SUBJECT: NuScale Power, LLC Response to NRC Request for Additional Information No. 132 (eRAI No. 8971) on the NuScale Design Certification Application

Response to Request for Additional Information

NRC Question No.: 03.08.04-13

Figure 4-19. Single Elements from Major Floor Slabs with Insufficient Thermal T0 Strain Capacity for Load Combination 9-6 in Y Direction.

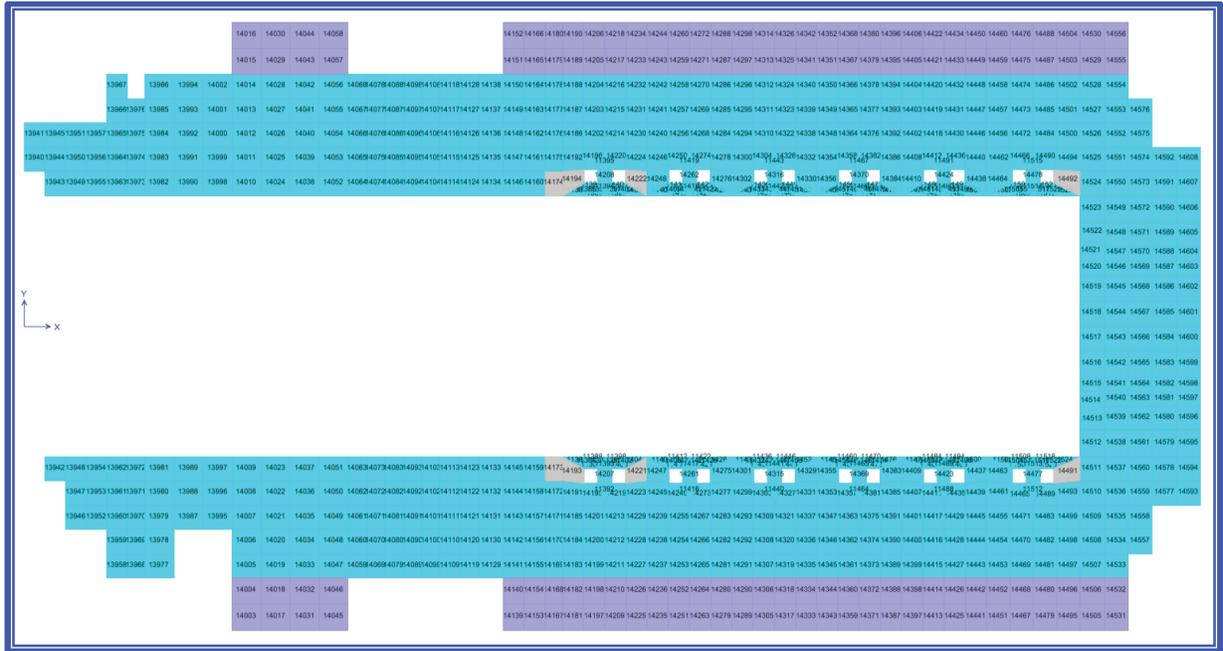
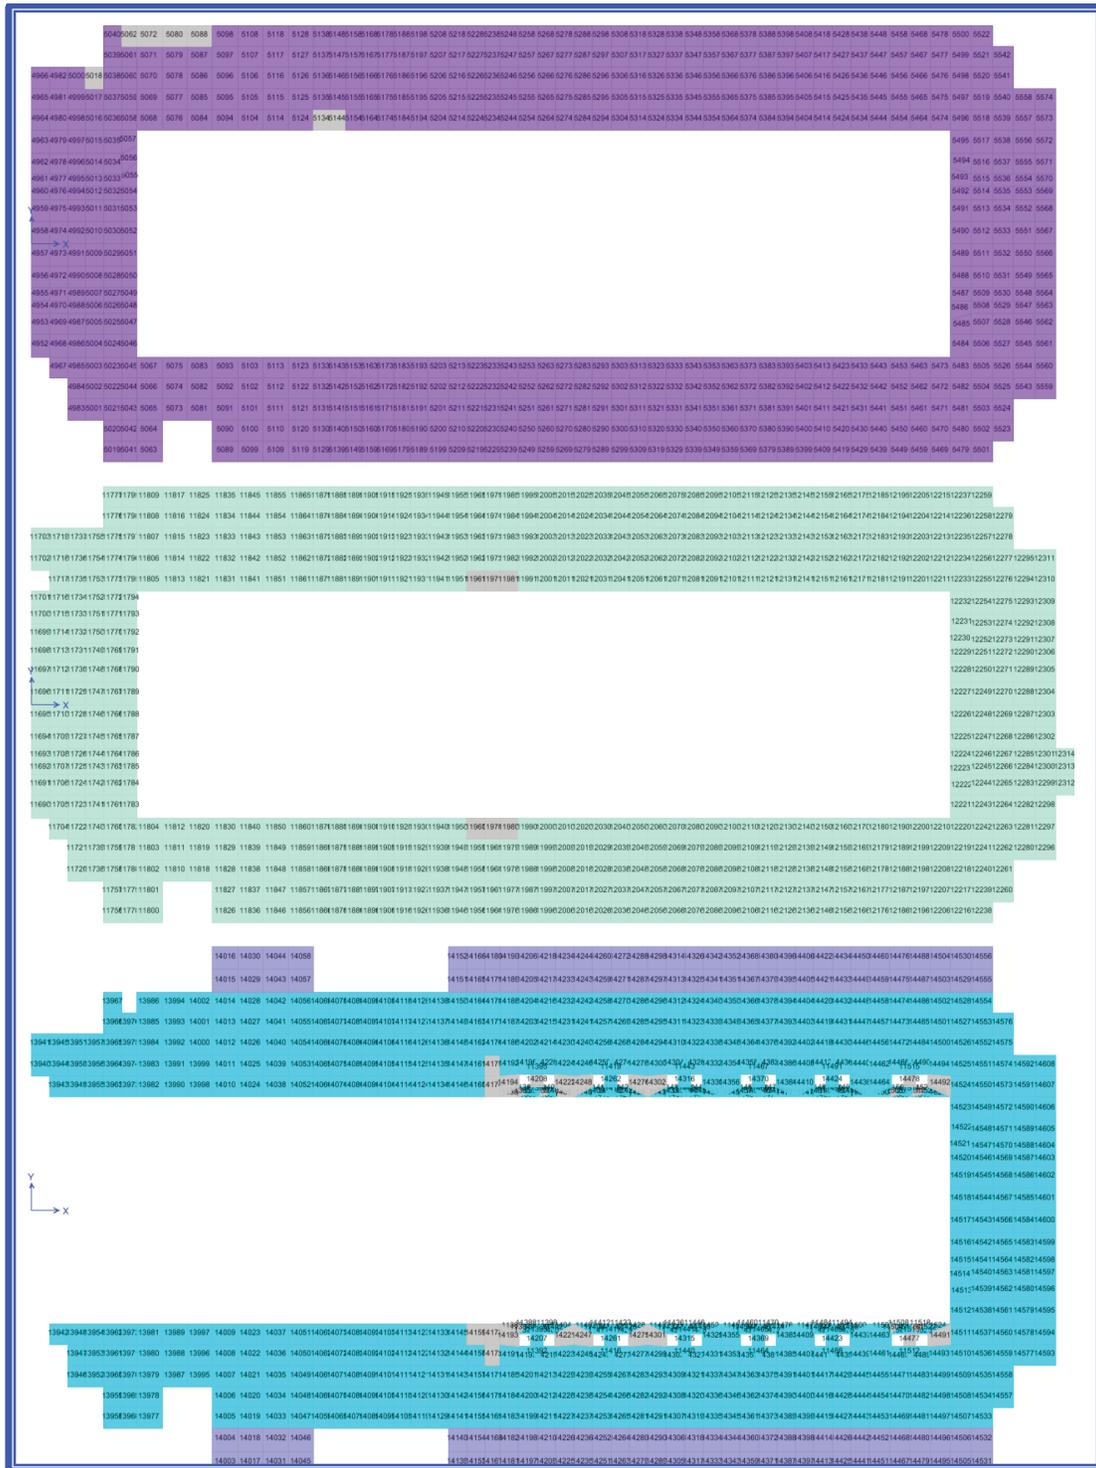
The maximum strains from SDH for any element for the different reinforcement configurations for these slabs are combined with thermal strains. Figure 4-15 shows the strain-based steel design check for this wall, where SDH strains are combined with T_0 strains for load combination 9-6 or T_a+P_a strains for load combination 9-9. For groups of elements where adding the maximum strain from T_0 would make the average fail, a more accurate T_0 strain was obtained based on its location using the strain contour. For groups of elements where adding the maximum strain from T_a+P_a would make the average fail, a more accurate T_a+P_a strain was obtained based on its location using the strain contour. Figure 4-19 and Figure 4-20 show the elements with insufficient capacity in Y-direction for load combinations 9-6 and 9-9 respectively.

Figure 4-21. Single Elements from Pilasters at Grid Line A with Insufficient Thermal T_0 Strain Capacity for Load Combination 9-6.

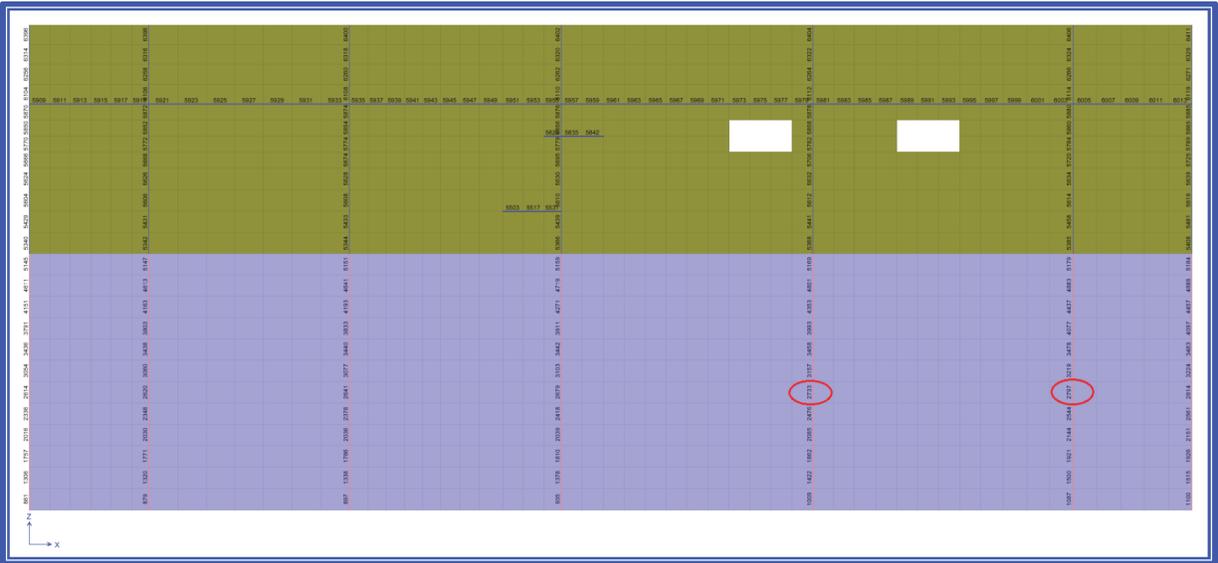
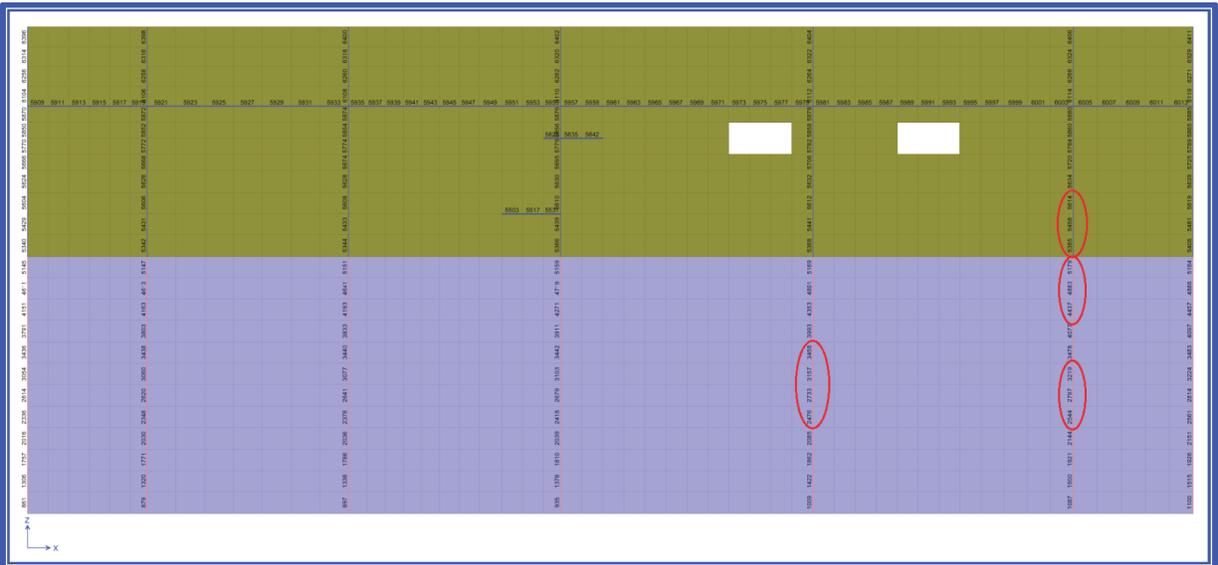
Figure 4-21 and Figure 4-22 show the elements that showed exceedances. An averaging for these exceeding elements is performed.

Figure 4-23. Single Elements from Buttress at TOC EL 126'-0" and 145'-0" with Insufficient Thermal T_a+P_a Strain Capacity for Load Combination 9-9.

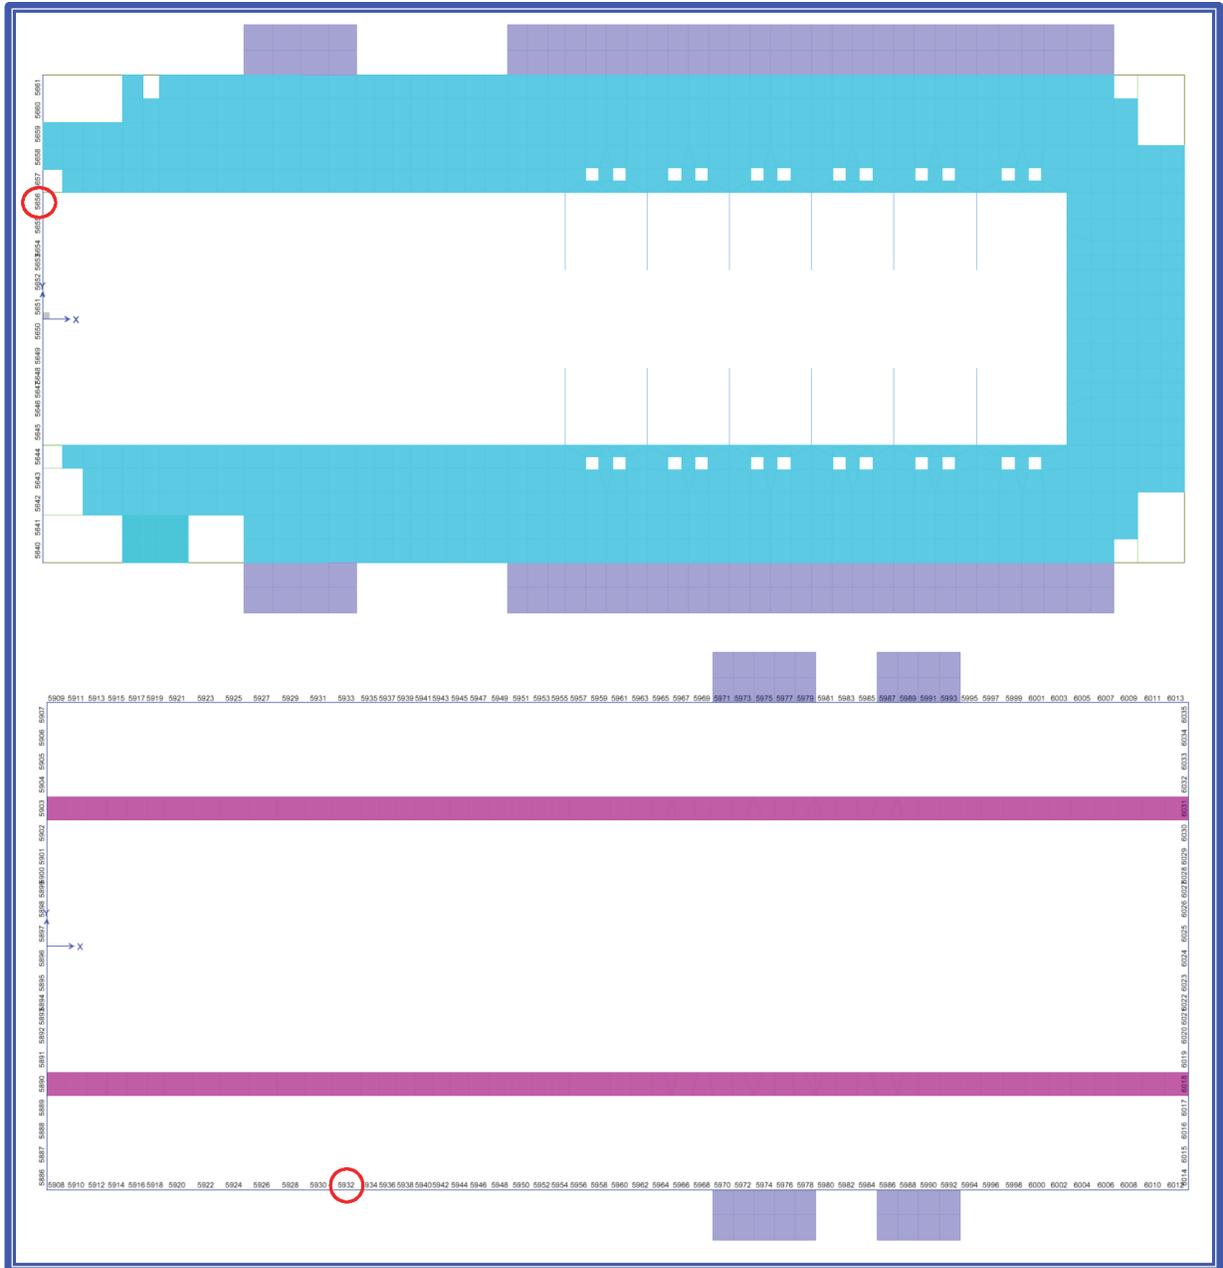
The buttresses at TOC EL 126'-0' and 145'-0" consist of a single reinforcement type. The maximum strains from SDH for any element for the different reinforcement configurations for these buttresses are combined with thermal strains. Table 4-19 shows the strain-based steel design check for this wall, where SDH strains are combined with T_0 strains for load combination 9-6 or T_a+P_a strains for load combination 9-9. The total strain in the steel is less than $1.2\epsilon_y$ (2.483×10^{-3}) at all locations for load combination 9-6. However, the total strain in the steel exceeds $1.2\epsilon_y$ (2.483×10^{-3}) for load combination 9-9. Figure 4-23 show the elements with exceedances. An averaging for these exceeding elements is performed.

Figure 4-24. Single Elements from T-Beams at TOC EL 50'-0", 75'-0", and 100'-0" with Insufficient Thermal T_a+P_a Strain Capacity for Load Combination 9-9.

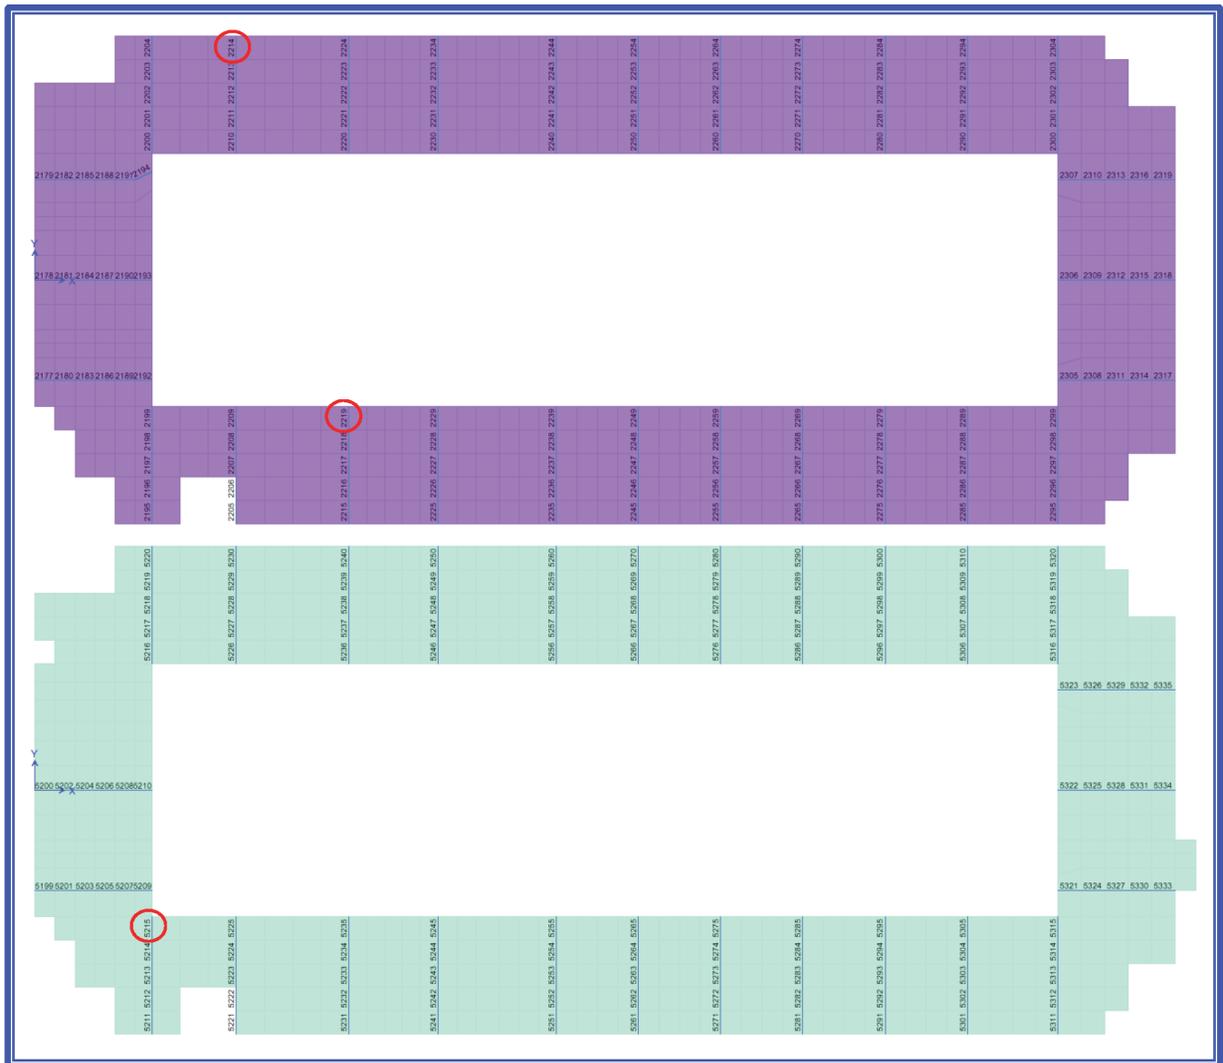
The total strain in the steel is less than $1.2\epsilon_y$ (2.483×10^{-3}) at all locations for load combination 9-6. However, the total strain in the steel exceeds $1.2\epsilon_y$ (2.483×10^{-3}) for two elevations for load combination 9-9 as shown in Figure 4-24.

An averaging for these exceeding elements is performed. After averaging the single elements without sufficient thermal capacity for load combination 9-9, therefore, the condition is satisfied and the wall is considered acceptable.
